82559ER Fast Ethernet PCI Controller

Stepping Information

October 2004

Revision 1.1

1. False Power Management Event Indication on Power Cycle

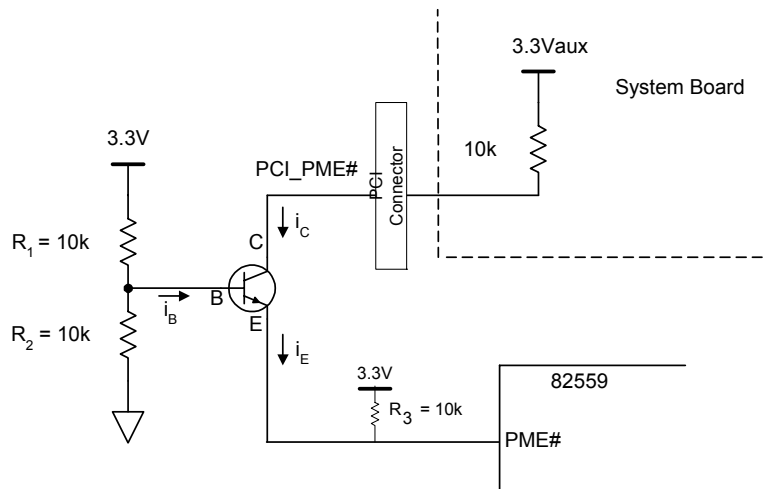
Problem: During power cycle events, the electrostatic discharge (ESD) elements internal to the 82559ER may falsely clamp the Power Management Event (PME) output signal to approximately 1.5 volts for 100 ms to 150 ms during initial power up. This can cause wake-up events to be recognized by the system if power management events are enabled in the system chipset. This may result in a problem for mobile environments since the false clamping can cause a suspended system to wake up when the power to the LAN device is transitioned.

Implication: The implications of this anomaly depend on the target system configuration. In desktop and server systems, the impact is limited to a false wake-up event occurring when a new card is installed. In mobile systems where the LAN power is transitioned more frequently, the PME signal should be disabled during transitions.

Workaround: False PME indications can be avoided by disabling the recognition of a PME before removing or restoring power to the 82559ER. If a hardware solution is required, the following isolation circuit has been proven to be effective. The circuit requires the PCI PME signal (PCI_PME#) to be isolated from the 82559ER PME signal (PME#). The system does not see the 1.5 voltage level drop caused by the 82559ER's power transition.
